Safety Recall Campaign

SC316

2020-2024MY
Telluride (ON)

FRONT POWER SEAT CONTROL SWITCH REPAIR/REPLACEMENT (SC316)

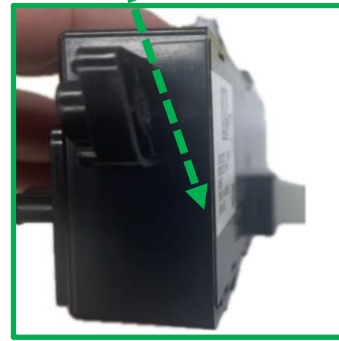
4. Confirm if the power seat control switch (B) backing plate IS or is NOT popped out.

- If the power seat control switch backing plate has is NOT popped out (OK), proceed to step 5.

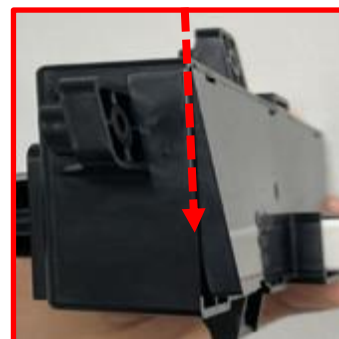
- If the power seat control switch backing plate IS popped out (NG), take one clear KVID photo of the NG switch including RO information, and then replace the power seat control switch by proceeding to 'Replacement Procedure' on page 7. then replace the power seat control switch by proceeding to 'Replacement Procedure' on page 7.

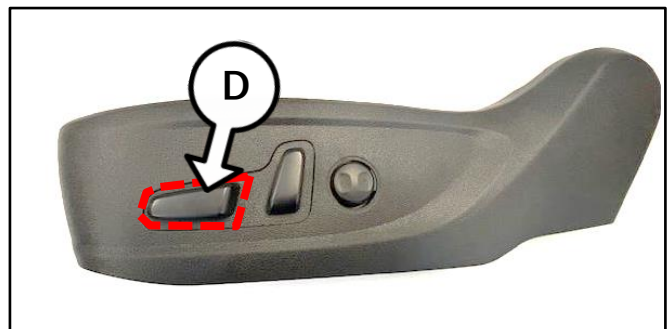
5. Using a non-marring trim removal tool, remove and discard the slide knob (D) by prying upwards.

Note: DO NOT reuse slide knob (D). Replace with new provided knob.

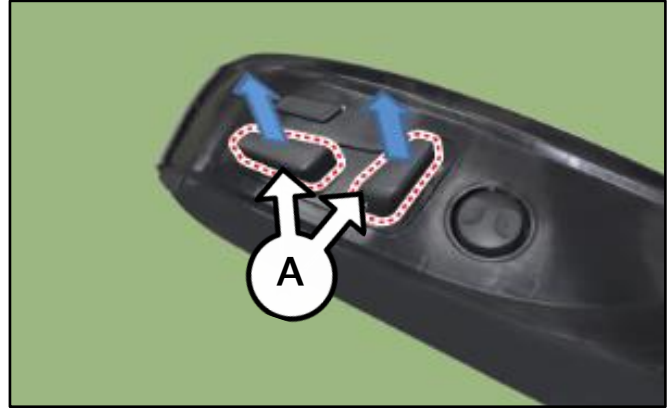
8. Install **new** slide knob (D).

3-Screw Type

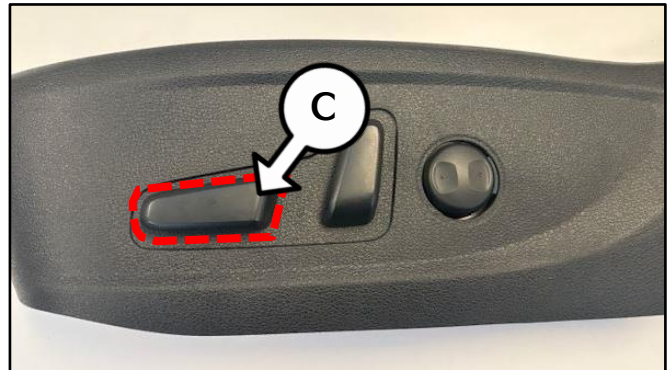
2. Loosen the three (3) or four (4) screws to remove the power seat control switch (B).

Tightening torque for screws:
88.5 lb.in (10.0 N.m)

The **NEW** switch does NOT require the bracket be installed.
